SUBJECT: *Comments on Draft Consequence Study, NRC-2013-013*

Declaration of 1 August 2013  
by Gordon R. Thompson:

Comments on the US Nuclear Regulatory Commission's  
Draft Consequence Study of a Beyond-Design-Basis  
Earthquake Affecting the Spent Fuel Pool  
for a US Mark I Boiling Water Reactor

**Figure VII-1**  
**One of the Pool Layouts Modeled in NRC's Draft Consequence Study: The OCP2, High-Density, 1x4 Case**

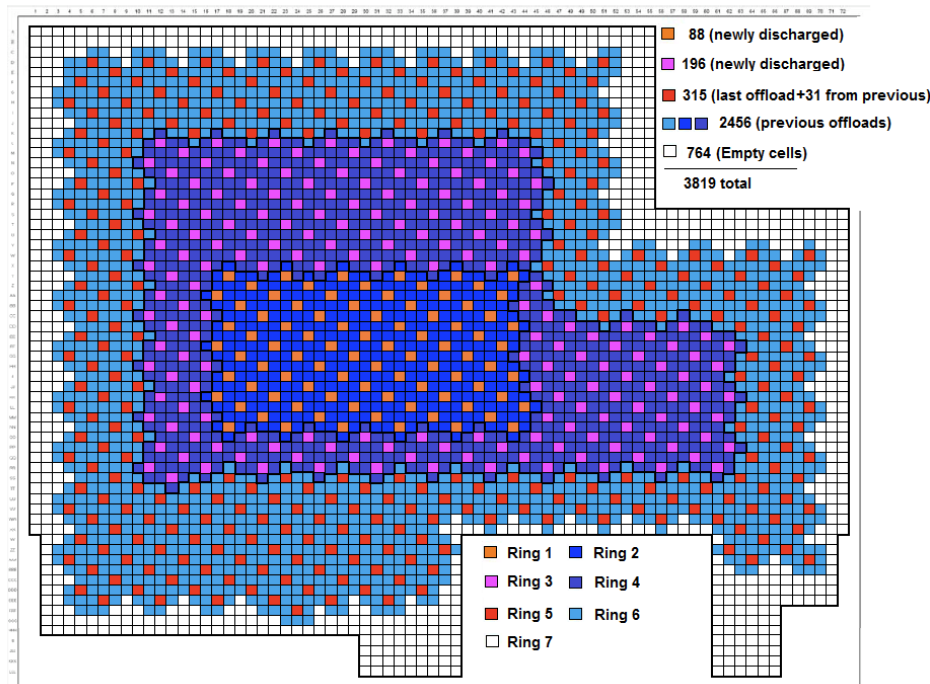
(VII-5) In addition to questions about the validity of MELCOR, there are questions about NRC's input assumptions. For example, how closely does the pool layout shown in Figure VII-1 correspond with actual practice in the nuclear industry? In that context, there is a puzzling NRC assumption associated with Figure VII-1. That figure shows a total of 284 newly-discharged fuel assemblies. Of these, 88 assemblies are assumed by NRC to produce decay heat at the rate of 10.9 kW per assembly when aged 20 days, while the remaining 196 assemblies produce 6.6 kW per assembly at the same age.<sup>47</sup> If this is typical practice, then licensees are forgoing substantial available burnup of the

majority of their fuel assemblies, with a resulting economic penalty.<sup>48</sup> As a related matter, Figure VII-1 shows a rather elaborate layout of fuel, whose achievement would involve substantial shuffling of assemblies. NRC says that this layout is comparatively favorable in terms of the risk of a pool fire. Yet, licensees are allowed a period of time, during and perhaps after a refueling outage, to perform the shuffling needed to achieve a favorable layout. The length of that period of time is a secret because, NRC says, this information could be useful to an adversary.<sup>49</sup> Thus, is it appropriate to assume, as a MELCOR input, that a comparatively favorable layout has been achieved before water is lost?

**Figure VII-2**  
**Findings from NRC's Draft Consequence Study: Water Level and Ring 1 Cladding Temperature for Unmitigated High-Density Moderate Leak (OCP4)**

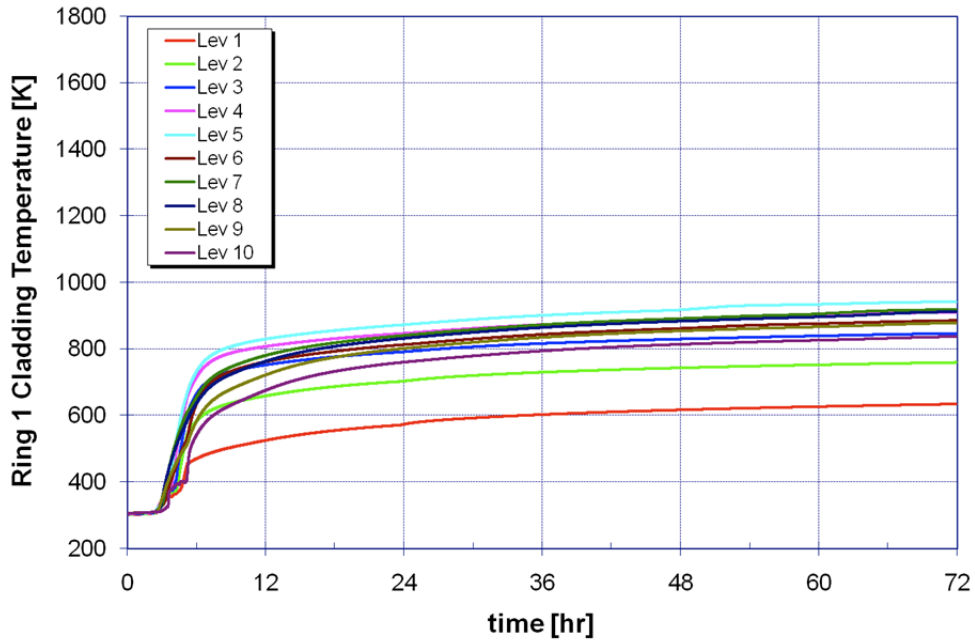
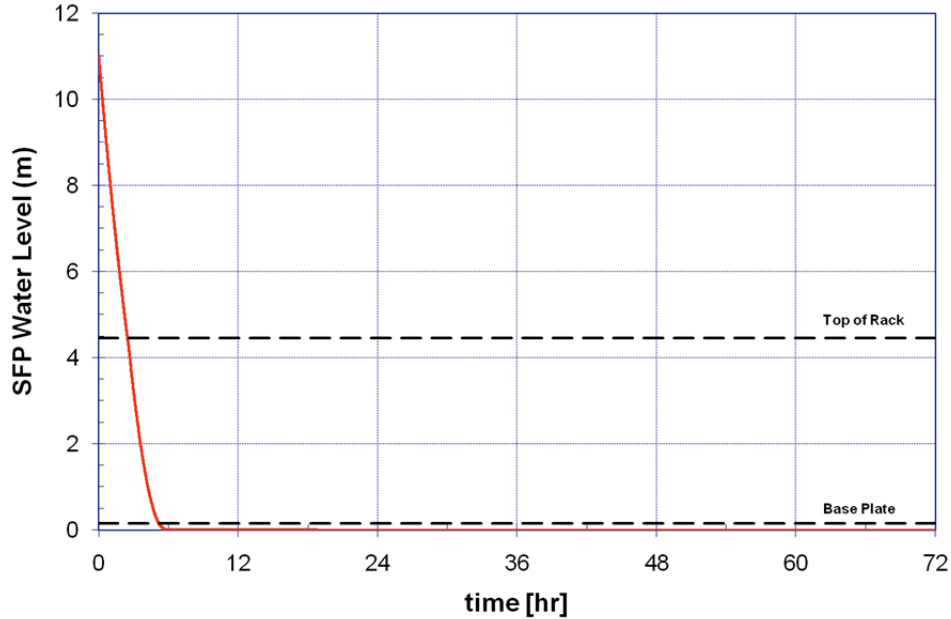
(VII-10) Now, consider MELCOR outputs for NRC's examination of a moderate-leakage case in OCP4, as shown in Figure VII-2. During the evolution of this case, there would be a period of time when the upper portion of the fuel is exposed and residual water is present. That period would extend from about  $t = 3$  hours to about  $t = 6$  hours. During that 3-hour period, at the "Lev 5" elevation of the fuel, cladding temperature would rise from about 300 K to about 700 K. Thus, the average rate of temperature rise would be about 130 K per hour. This finding indicates that the exposed portion of the fuel at the Lev 5 elevation would be in an approximately adiabatic situation, at least for temperatures up to 700 K.

**Figure VII-3**  
**Findings from NRC's Draft Consequence Study: Water Level and Ring 1 Cladding Temperature for Unmitigated High-Density Small Leak (OCP4)**

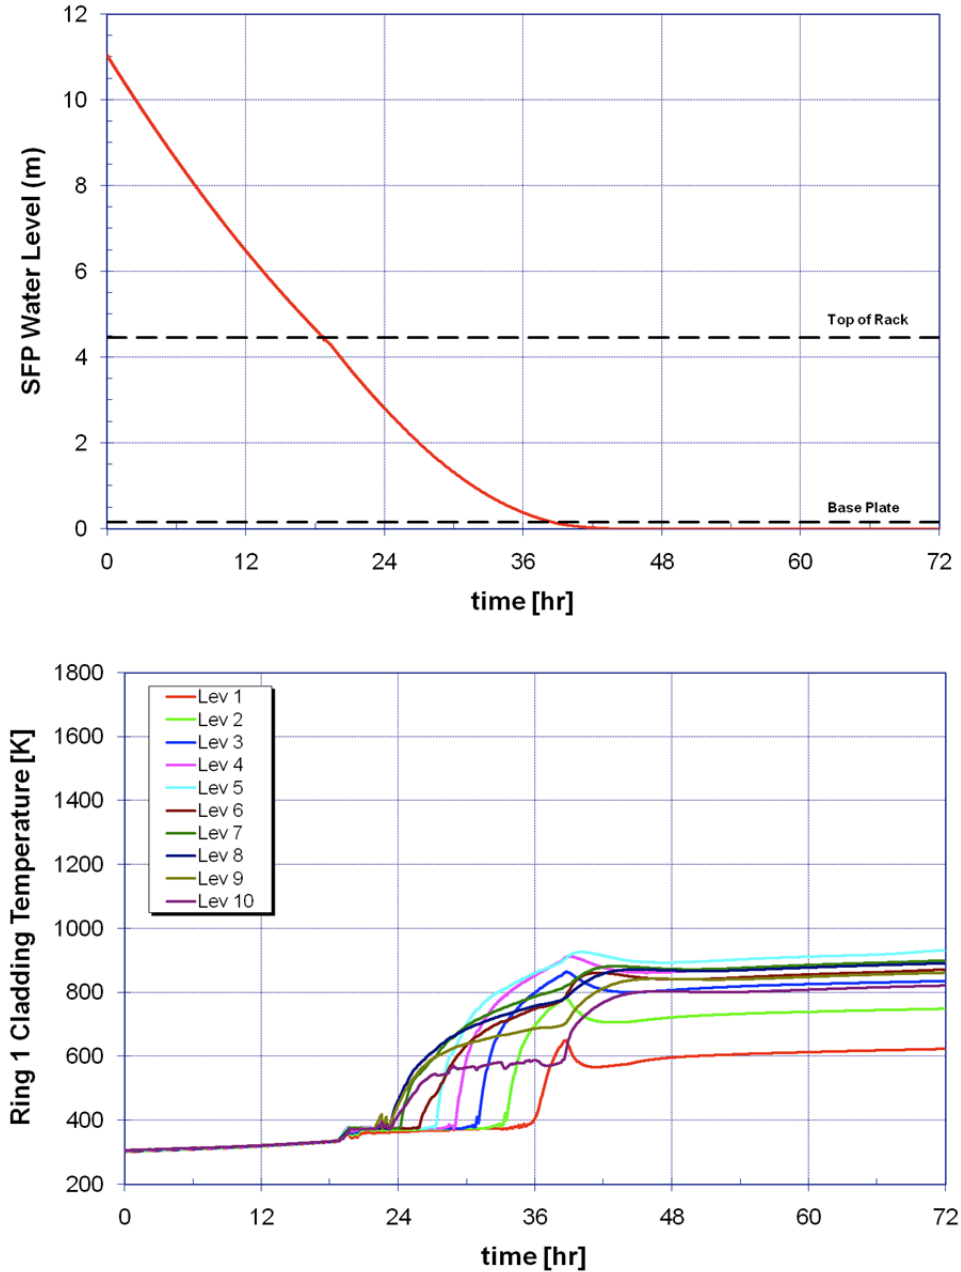
(VII-11) Now, apply the same process, as in the preceding paragraph, to NRC's examination of a small-leakage case as shown in Figure VII-3. In that case, the period of time when fuel at the Lev 5 elevation is exposed and residual water is present would extend from about  $t = 28$  hours to about  $t = 40$  hours. During that 12-hour period, the temperature of fuel cladding at the Lev 5 elevation would rise from about 350 K to about 900 K. Thus, the average rate of temperature rise would be about 46 K per hour.
